UNITED STATES PATENT AND TRADEMARK OFFICE

Office Action Summary	Application No.	Applicant(s)
	10/809,773	ZURECKI ET AL.
	Examiner	Art Unit
	William C. Doerrler	3744

DETAILED ACTION

FIG. 1A

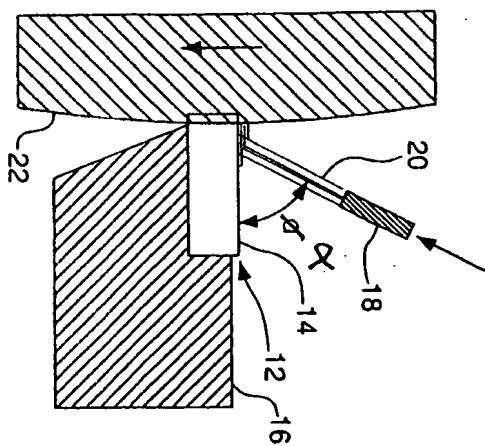
a amended to
read α

FIG. 1B

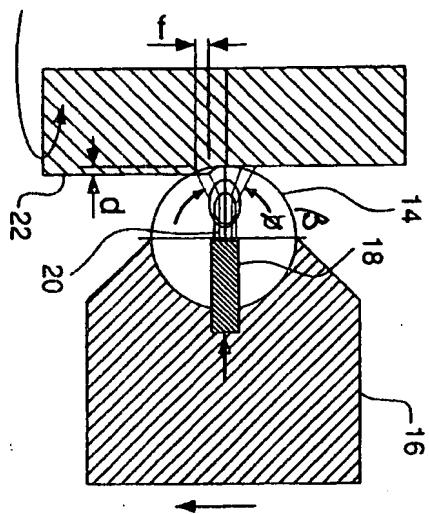
b amended to
read β
